Access Compliance Report

Public Rights-of-Way

(Curb Ramps)

Intersection ID: 2778	Main Street: HIGHLAND_CREEK_PY	Cross Street: BRADWELL_DR	Location: S
ADA ID: 922E9C586E2E	Ramp Type: PerpDiag	Initial Pass/Fail: Pass	Overall Compliance: No
Severity Score: 2.75			
Codes/Mitigation Info/Possible Solution		Field Measurements/Component Compliance

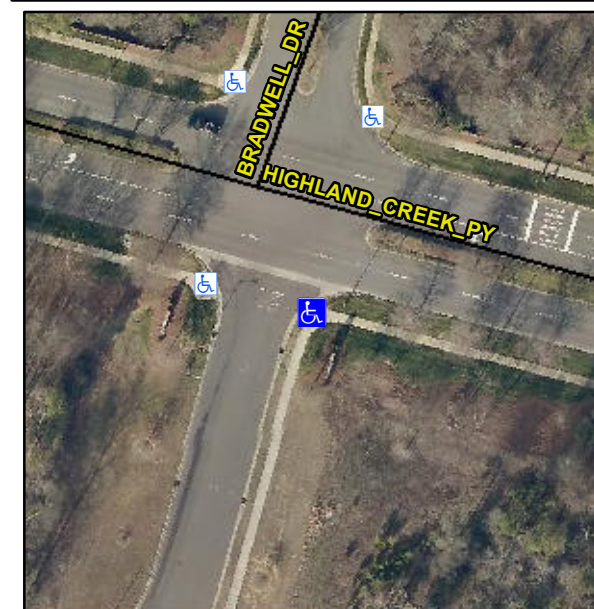
R304.5.3, R304.2.2-Perp, R304.3.2-Para, R304.2.3

Compliance	Description	Data	Compliance	Description	Data
N/A	Ramp Length (in)	69.0	Yes	Ramp Slope (%)	7.7
Yes	Ramp Width (in)	48.0	No	Ramp XSlope (%)	3.5
N/A	Flare Type LT	Sloped	N/A	Flare Type RT	N/A
N/A	Flare Slope LT (%)	2.9	No	Flare Slope RT (%)	10.9
N/A	Flare Traversable LT?	Yes	N/A	Flare Traversable RT?	Yes
Yes	Landing Length (in)	60.0	Yes	DWS Provided?	Yes
Yes	Landing Width (in)	48.0	Yes	DWS Contrast?	Yes
No	Landing Slope (%)	2.5	Yes	DWS Length (in)	24.0
No	Landing X Slope (%)	3.6	Yes	DWS Full Width?	Yes
N/A	Landing Curb? (Y/N)	No	Yes	DWS Offset (in)	1.0
N/A	Shared Landing?	No			
Yes	Gutter Ponding?	No	Yes	Gutter Slope (%)	1.3
Yes	Gutter Lip Ht (in)	0.0	No	Gutter X Slope (%)	4.3
N/A	Painted X Walk1?	No	N/A	Painted X Walk2?	No
	X Walk 1 Direction	To NE		X Walk 2 Direction	To NW
N/A	X Walk 1 Width (in)	N/A	N/A	X Walk 2 Width (in)	N/A
	X Walk 1 Slope (%)	8.6		X Walk 2 Slope (%)	2.7
	X Walk 1 X Slope (%)	1.4		X Walk 2 X Slope (%)	7.2

N/A	Ramp inside XWalk1?	N/A	N/A	Ramp inside XWalk2?	N/A
	Road Slope (%)	4.8	N/A	Clear Space?	Yes
	Road X Slope (%)	7.1	N/A	Clear Space to XWalk (in)	N/A
Yes	Any Obstructions?	No	Yes	Storm Grate/Utility Hazard?	No
	Obstruction Type			Storm Grate/Utility Type	
		N/A			N/A
			Yes	Surface Condition? (G/P)	Good

Remove & Replace Curb Ramp With Two New Directional Ramps or Equivalent. Remove & Replace Gutter.
